CITY OF KENORA
KEEWATIN CHANNEL BRIDGE
RECOATING AND STEEL REPAIR PROJECT
ADDENDUM #4
MAY 30, 2025

Attached is Addendum #4 dated May 30, 2025 to the Tender Documents for the City of Kenora Keewatin Channel Bridge Recoating and Steel Repair Project.

This Addendum is being issued to revise portions of the tender documents, or provide additional information for the City of Kenora Keewatin Channel Recoating and Steel Repair Project. In the event of conflicts, this Addendum shall govern over all earlier documents.

Drawing No. S-102 Sheet 4 of 8 Revision 1

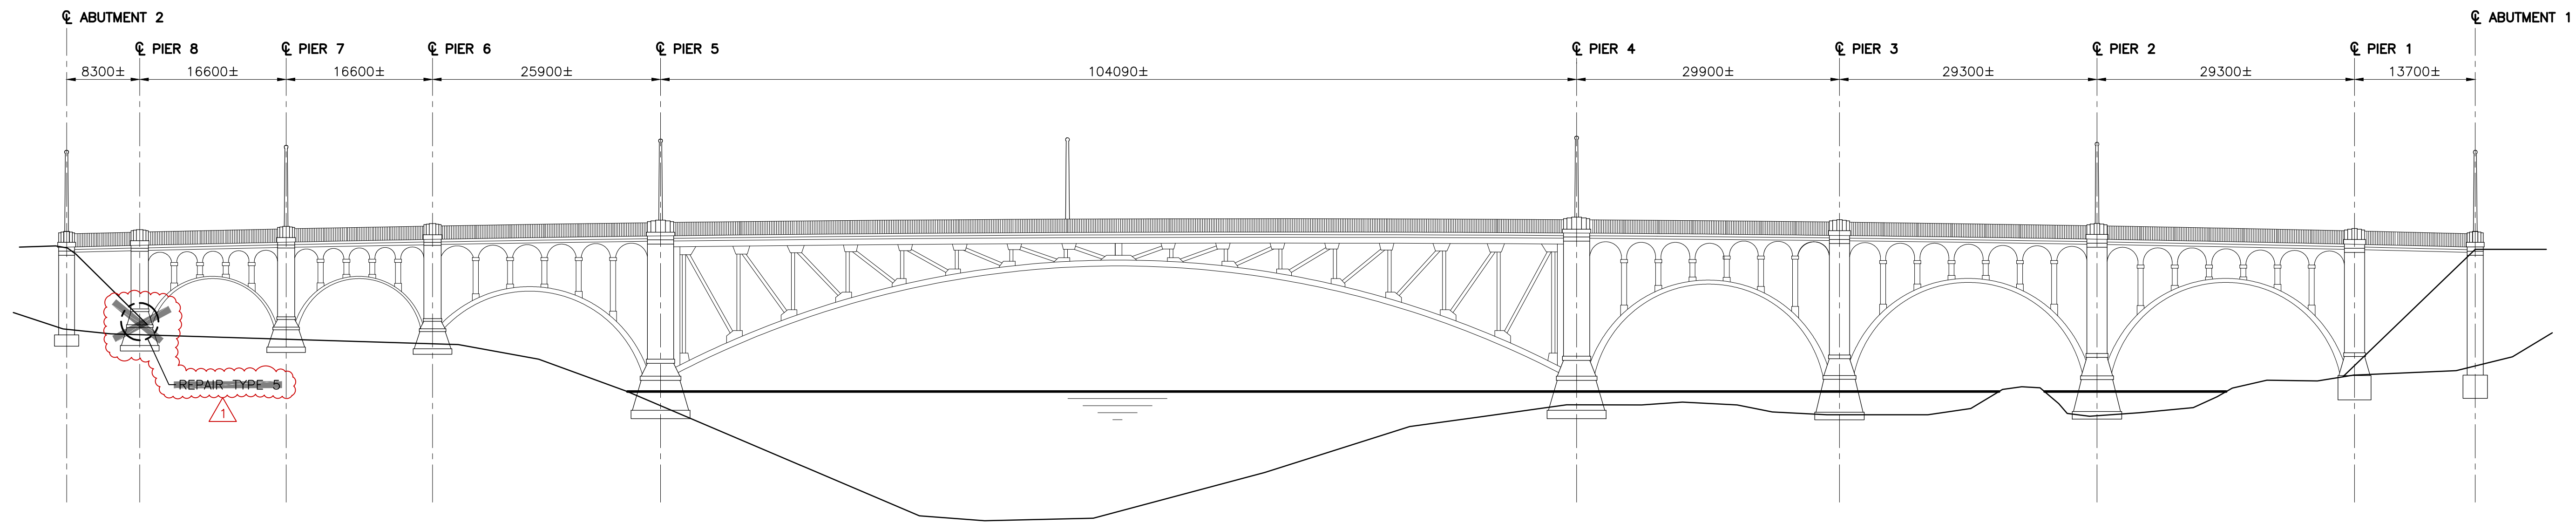
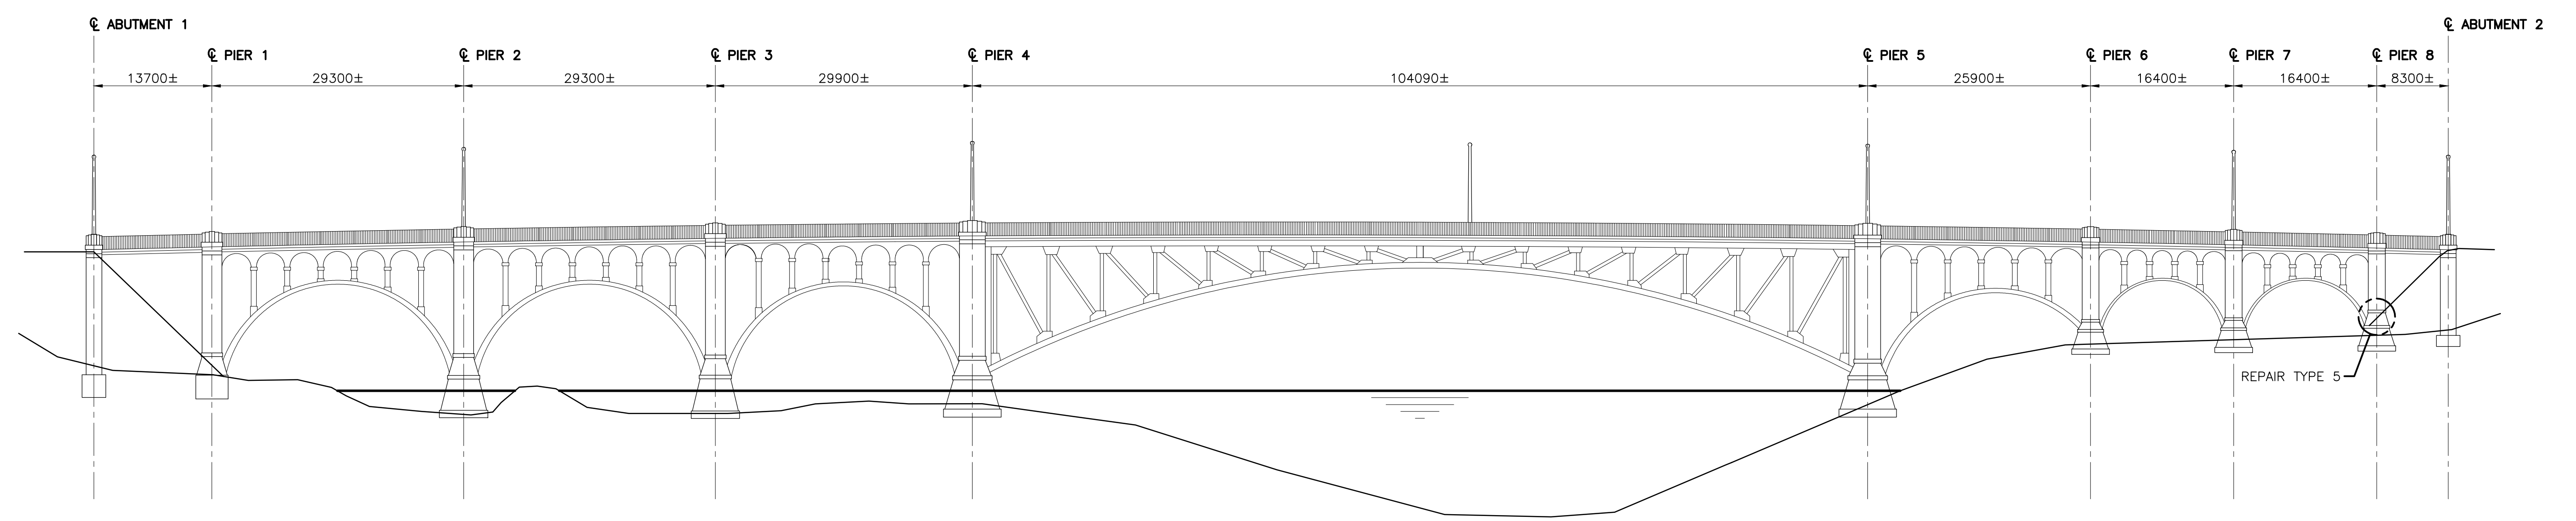
S-102 (Sheet 4 of 8)

Removal of Repair Detail 5 at select locations

5			
4			
3			
2			
1	REMOVE REPAIR LOCATION	J.M.B.	E.R.T. 2025.05.30
Revision		By	Appd. YY.MM.DD
E			
D			
C			
B	ISSUED FOR ADDENDUM No.4	J.M.B.	E.R.T. 2025.05.30
A	ISSUED FOR TENDER	J.M.B.	E.R.T. 2025.05.05
Issued		By	Appd. YY.MM.DD

Project No. 113733903	Scale 1:20	
Drawing No. S-104	Sheet 6 of 8	Revision 1

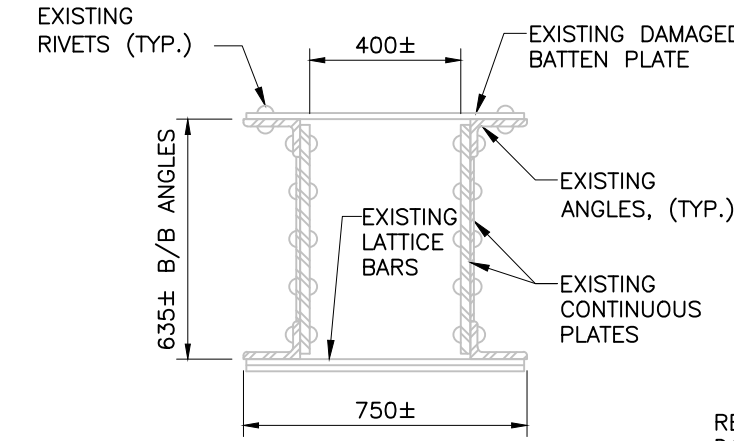
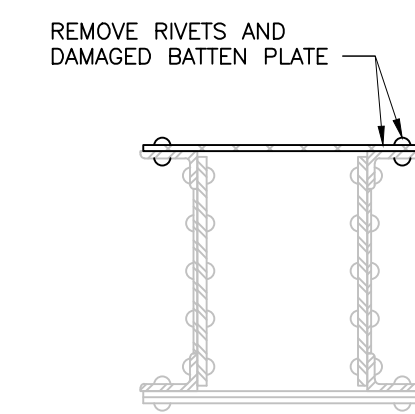
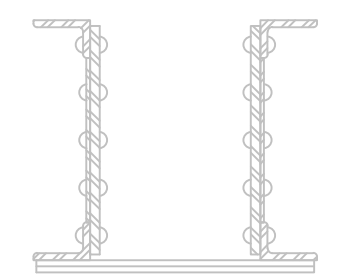
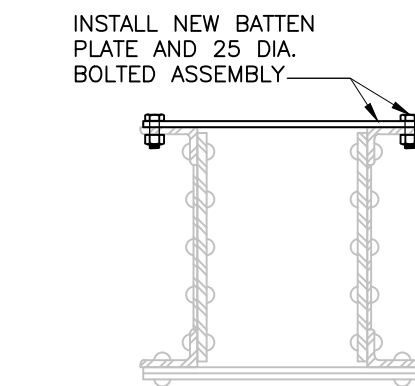
S-104 (Sheet 6 of 8)

Update to batten plates to accurately reflect total number of existing rivets

5			
4			
3			
2			
1	REVISED BATTEN PLATES	J.M.B.	E.T.T. 2025.05.30
Revision		By	Appd. YY.MM.DD
E			
D			
C			
B	ISSUED FOR ADDENDUM No.4	J.M.B.	E.T.T. 2025.05.30
A	ISSUED FOR TENDER	J.M.B.	E.T.T. 2025.05.05
Issued		By	Appd. YY.MM.DD

S-105

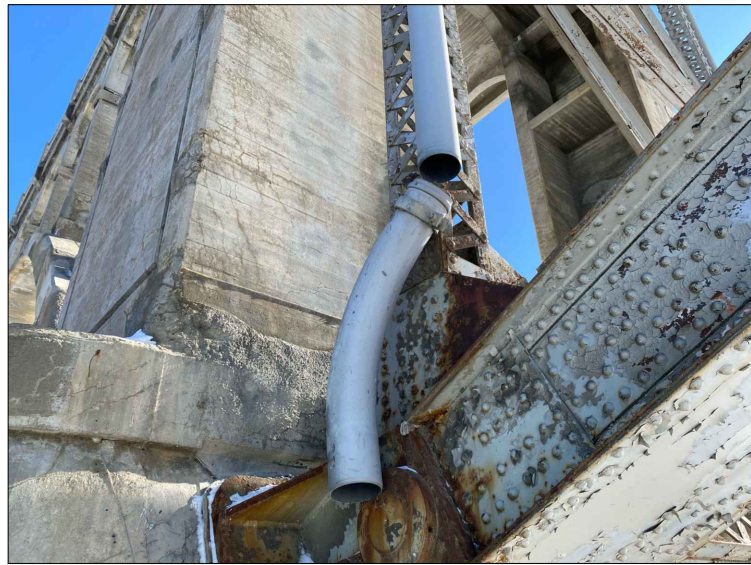
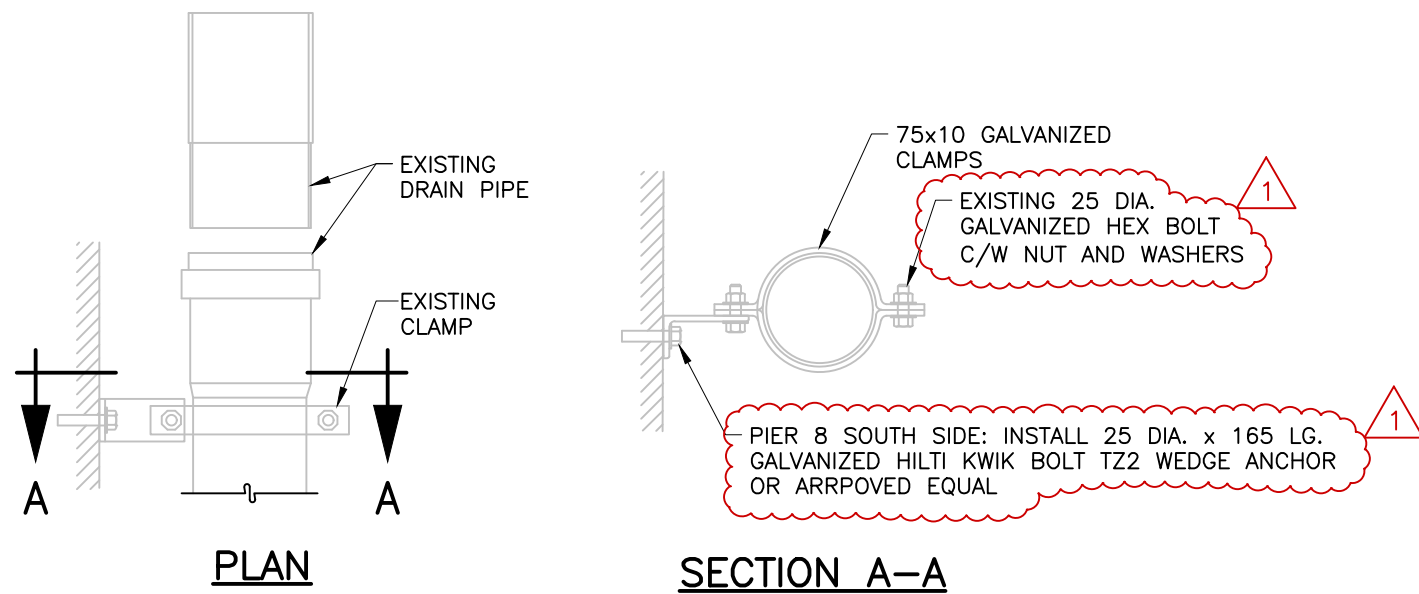
S-105 (Sheet 7 of 8)

Update to bolt dimensions for Repair Detail 5, as well as modification to Repair Detail 5 at Pier 8 south side.

5				
4				
3				
2				
1	REPAIR TYPE 5 NOTES	J.M.B.	E.R.T.	2025.05.30
Revision		By	Appd.	YY.MM.DD
E				
D				
C				
B	ISSUED FOR ADDENDUM No.4	J.M.B.	E.R.T.	2025.05.30
A	ISSUED FOR TENDER	J.M.B.	E.R.T.	2025.05.05
Issued		By	Appd.	YY.MM.DD

S-106

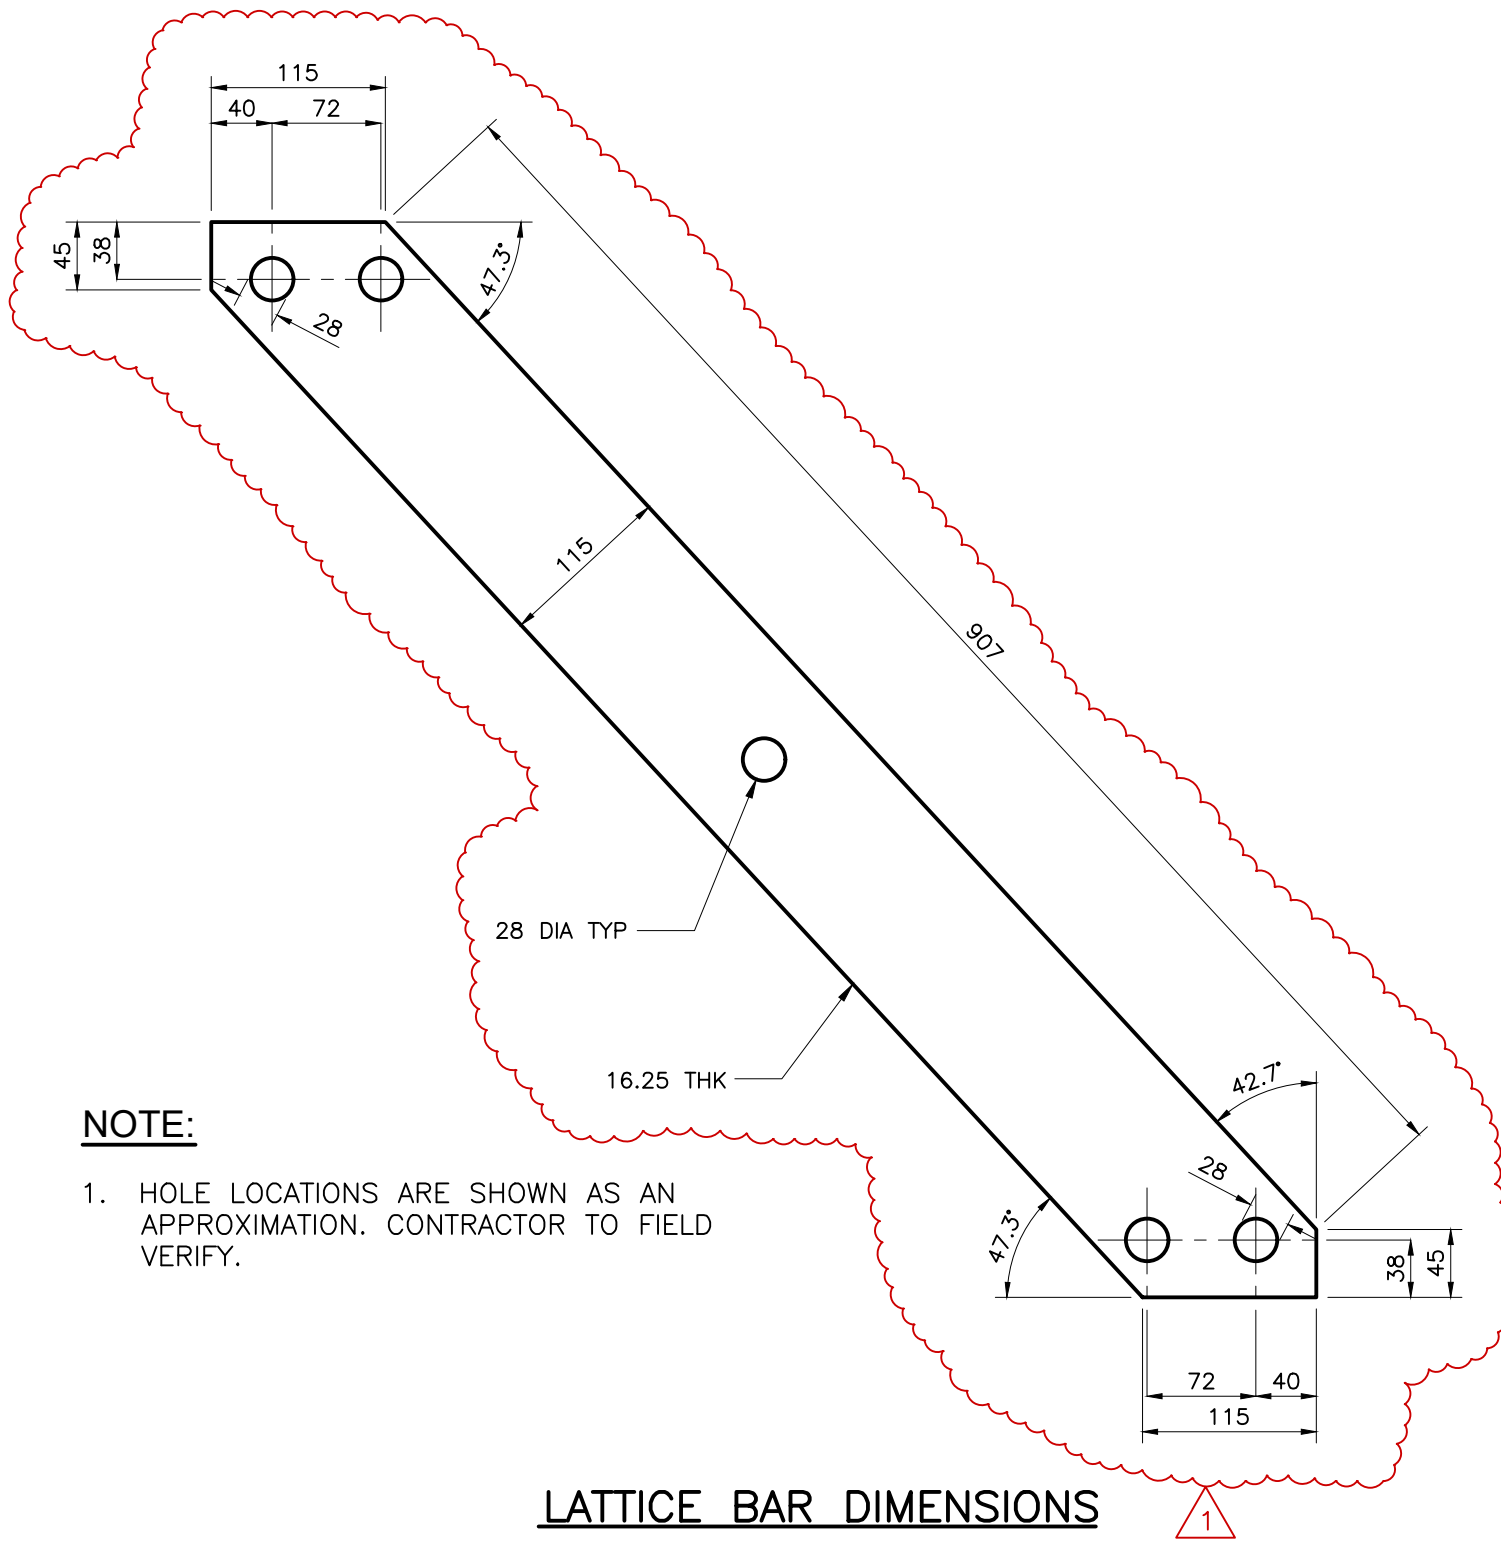
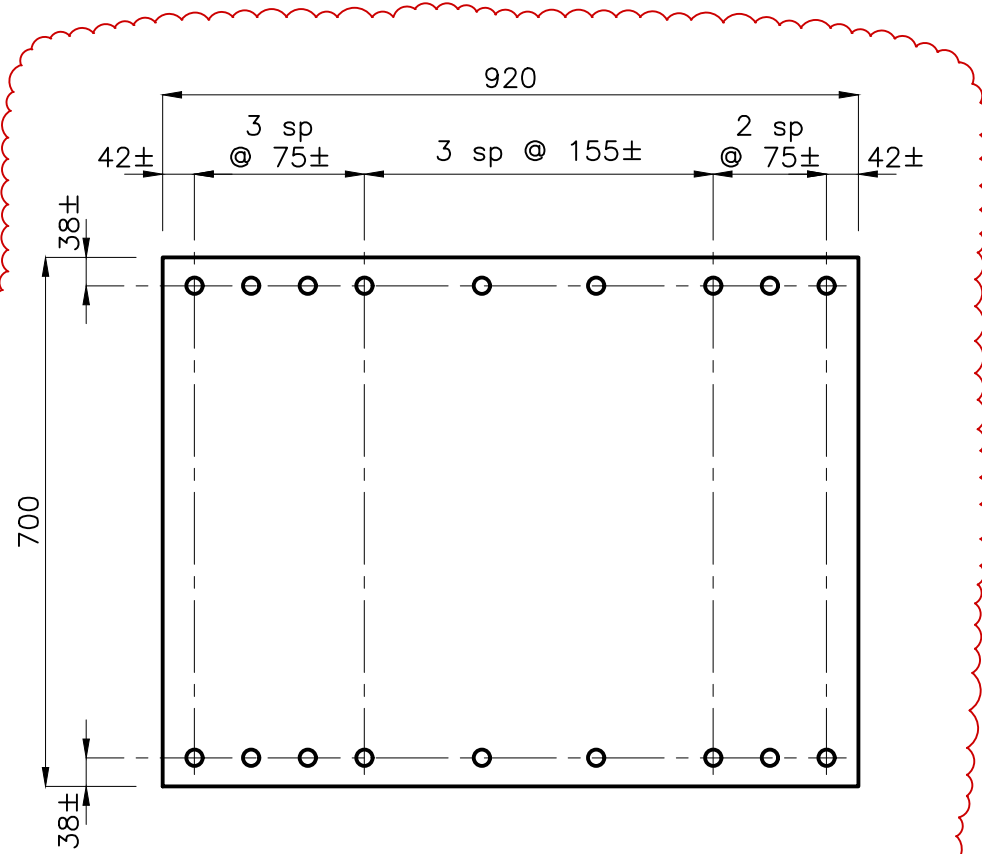
S-106 (Sheet 8 of 8)

Batten plate dimensions have been updated

Lattice bar dimensions have been updated

5			
4			
3			
2			
1	REVISED LATTICE BAR & ADDED BATTEN PLATE	J.M.B.	E.R.T. 2025.05.30
Revision		By	Appd. YY.MM.DD
E			
D			
C			
B	ISSUED FOR ADDENDUM No.4	J.M.B.	E.R.T. 2025.05.30
A	ISSUED FOR TENDER	J.M.B.	E.R.T. 2025.05.05
Issued		By	Appd. YY.MM.DD
